REMARKS

Claims 1-13 are now pending in the application. Claims 14-20 are cancelled. The Examiner is respectfully requested to reconsider and withdraw the rejection(s) in view of the amendments and remarks contained herein.

Figure - 2

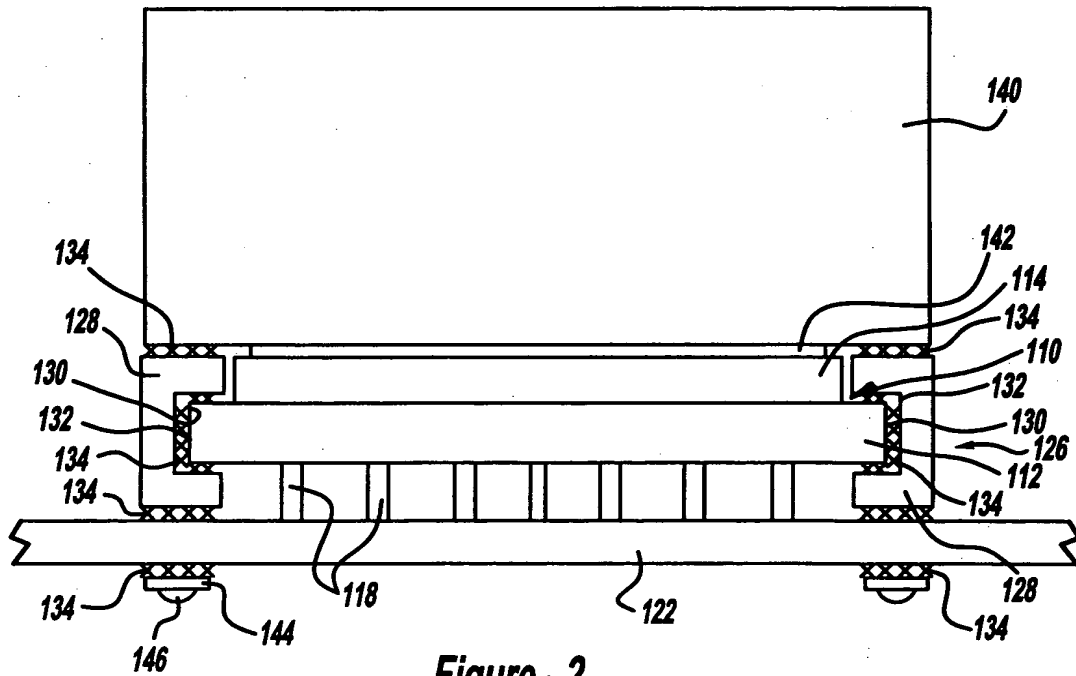
The drawings stand objected to as failing to comply with 37 CFR 1.84(p)(4) because reference characters "114" and "110" have both been used to designate for a package lid and the integrated package and characters "212" and "214" have both been used to designate for a package lid. This rejection has been accommodated.

The attached sheets of drawings include changes to Figures 2 and 3. With regard to Figure 2, the lead line and arrow point for reference numeral 110 has been modified to better indicate that it refers to the integrated circuit package and not just to the package lid 114. With regard to Figure 3, the lead line for reference numeral 212 has been extended to properly refer to the substrate. The attached sheets, which includes Figures 2 and 3, replace the original drawing sheets.

At page 8, lines 1 and 2, the specification expressly states that the heat sink 140 is an additional component with respect to the preferred embodiment as illustrated in Figure 2. Thus, Applicants respectfully assert that the additional component of the claims is properly illustrated in the drawings as required by 37 CFR 1.83 (a).
